Multichannel Network Interface Controller for HDLC with Extensions MUNICH32X

PEB 20321 Version 2.1

Delta Sheet 02.98

This Delta Sheet describes the differences between MUNICH32X Version 2.1 (Data Sheet 01.98 DS1) and MUNICH32X V1.2 (Data Sheet 05.97 T2032-1V11-7600).

Figure 52 De-multiplexed Bus Cycle

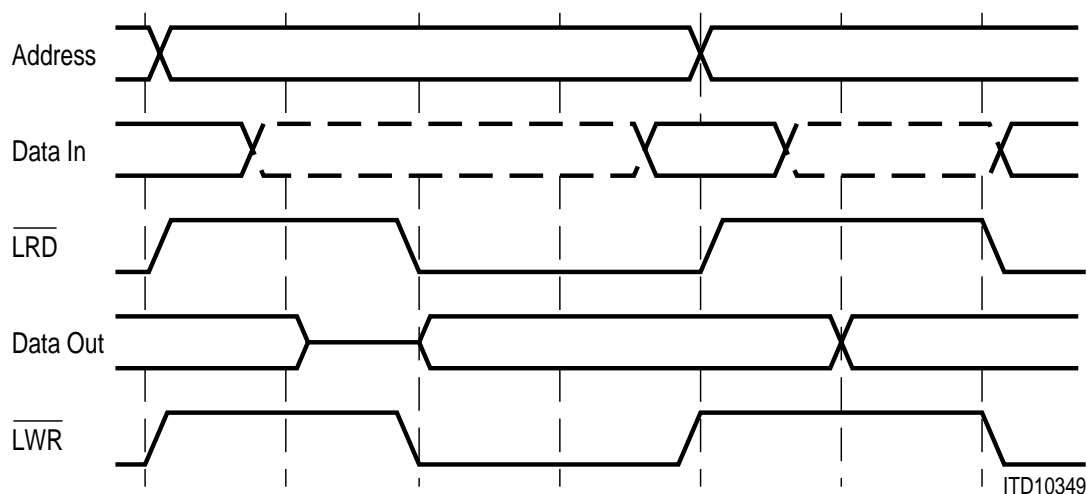
The Address Latch Enable (LALE) signal is used to mark the address phase in **Multiplexed Bus Modes** and triggers external latches to capture the current address with its falling edge. After a period of time the address is removed and data transfer cycle starts.

Although this signal was generated by MUNICH32X Version 1.x independent of the selected bus mode it is obsolete and thus **not supported by MUNICH32X V2.1 in De-multiplexed Bus Mode**.

Signal LALE is deleted from figure 52 describing the de-multiplexed bus cycle.
